**PSD NEW OPERATIONS CENTER PHASE 3
MAJOR PLAN 2024-101
ATTACHMENTS**

TO: PLANNING COMMISSION
FROM: GREGG R. ADAMS, PLANNER
SUBJECT: PSD NEW OPERATIONS CENTER PHASE 3
MAJOR PLAN 2024-101
REQUEST FOR PRELIMINARY/FINAL PLAN REVIEW
DATE: JUNE 7, 2024
COPIES: BOARD OF COMMISSIONERS, T. PETRUCCI, D. MANHARDT,
L. HARRIER, J. ZATOR, ESQ., J. ALDERFER, ESQ, A.
TALLARIDA, S. PIDCOCK, APPLICANT, SUB. FILE 2024-101

Re: South Whitehall Township
Parkland School District
New Operations Center Phase 3
Major Plan #2024-101
Transportation Impact Assessment
Review

SUBJECT: South Whitehall Township
Parkland School District New Operations Center Phase 3
Major Plan #2024-101
Final Plan Review

DRAWING TITLE LANDSCAPE AND SIGNAGE PLAN

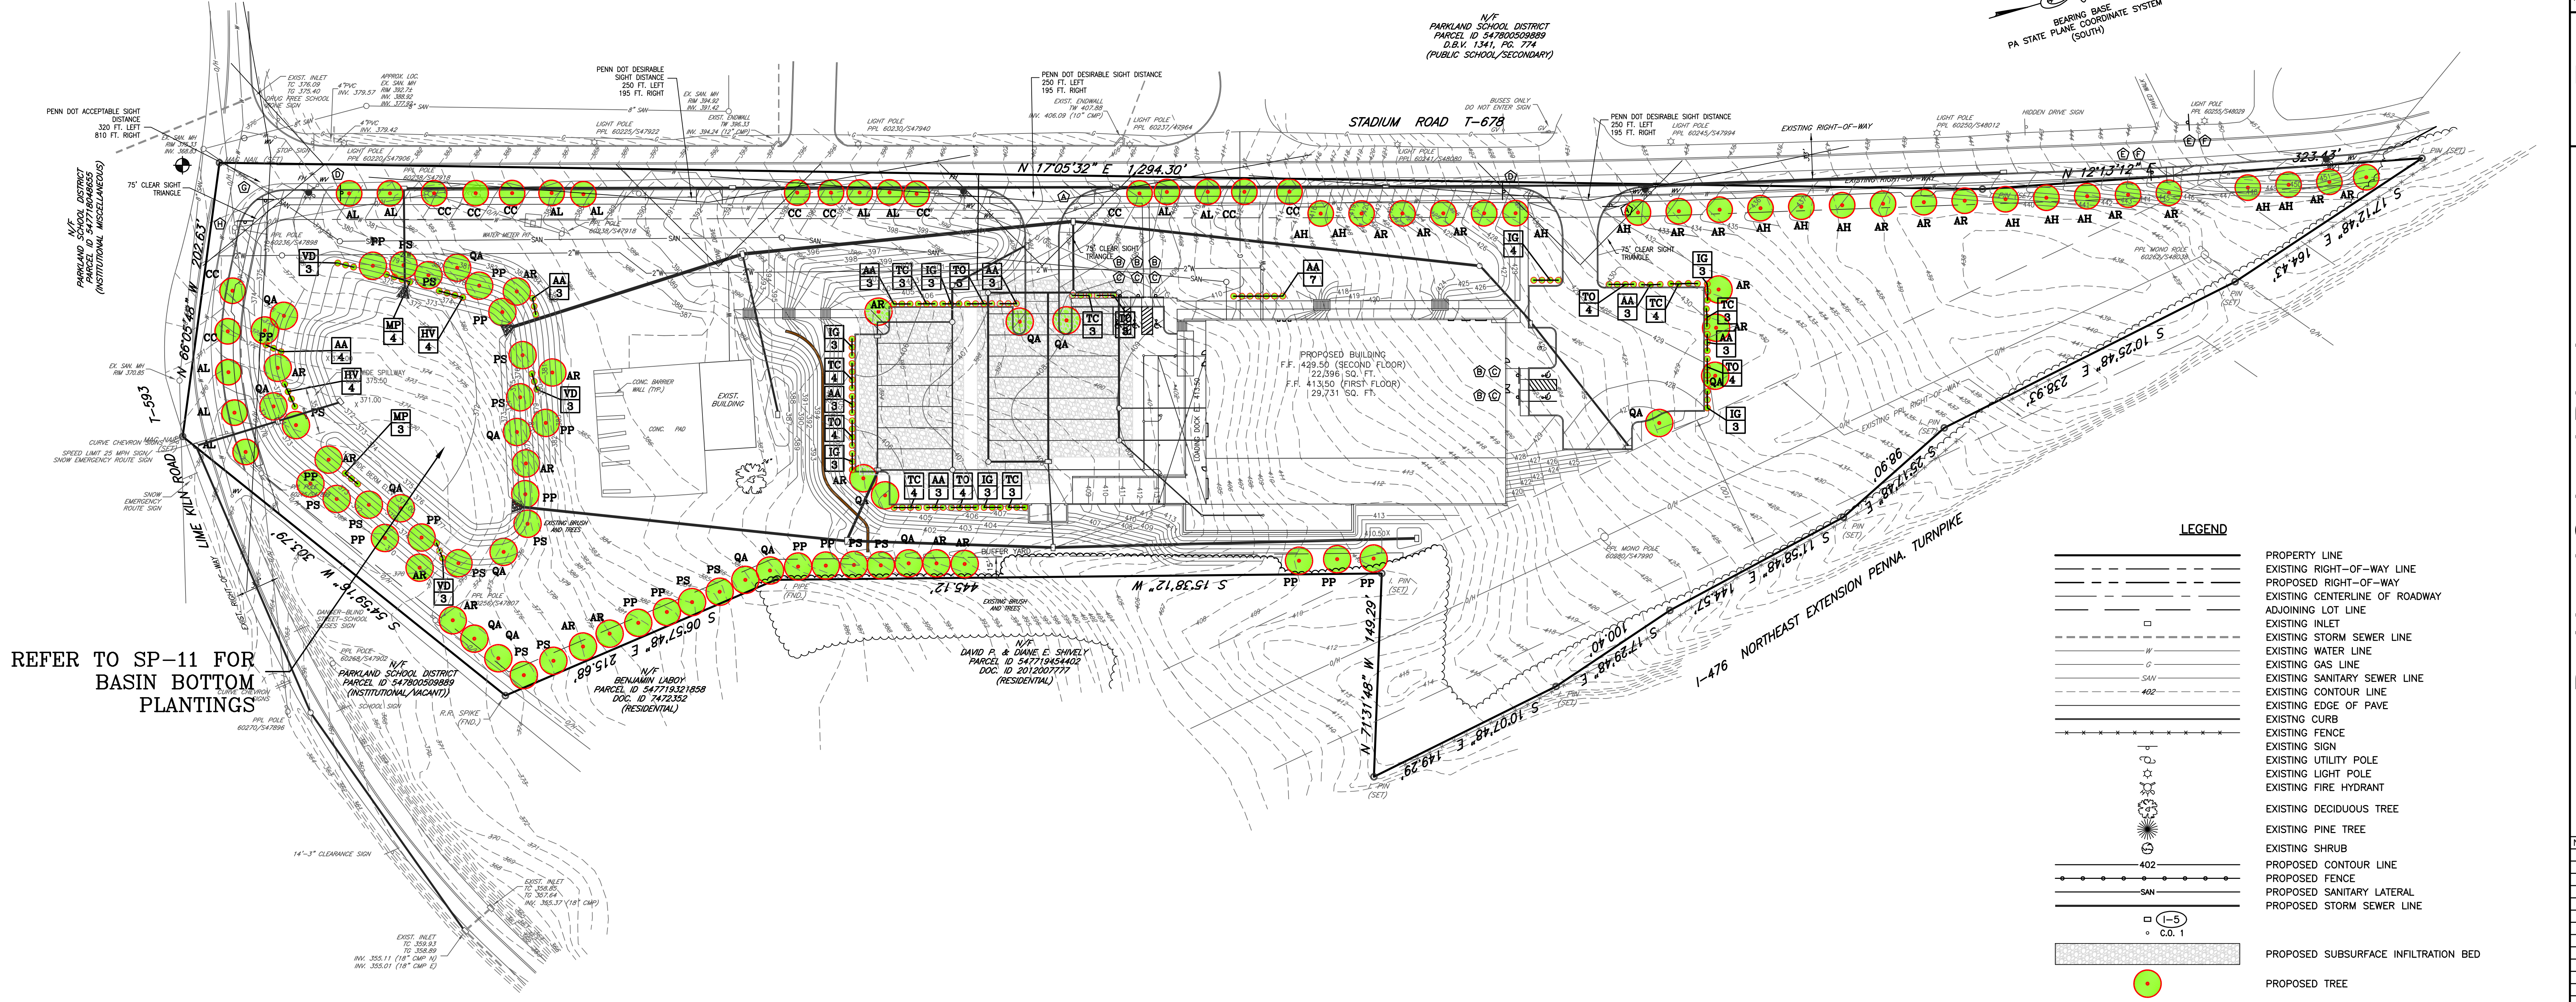
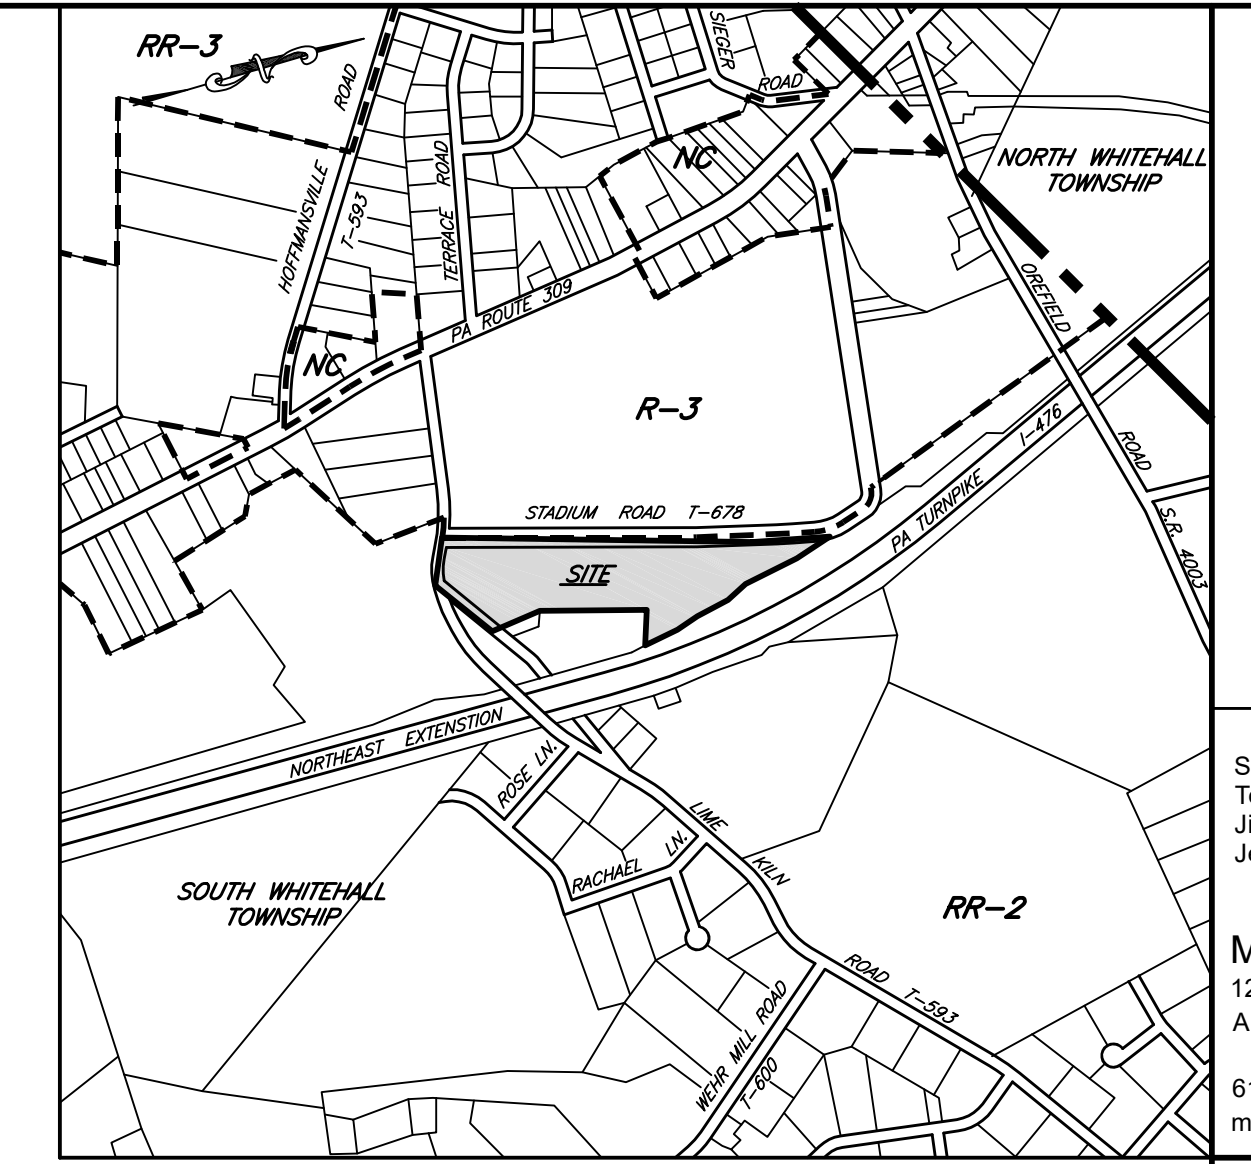
- b. The Applicant shall provide all buffering as stated on the Landscaping Plan.
 - c. The Applicant's total number of employees and visitors shall not exceed 94 per day unless further relief is granted by the ZHB.
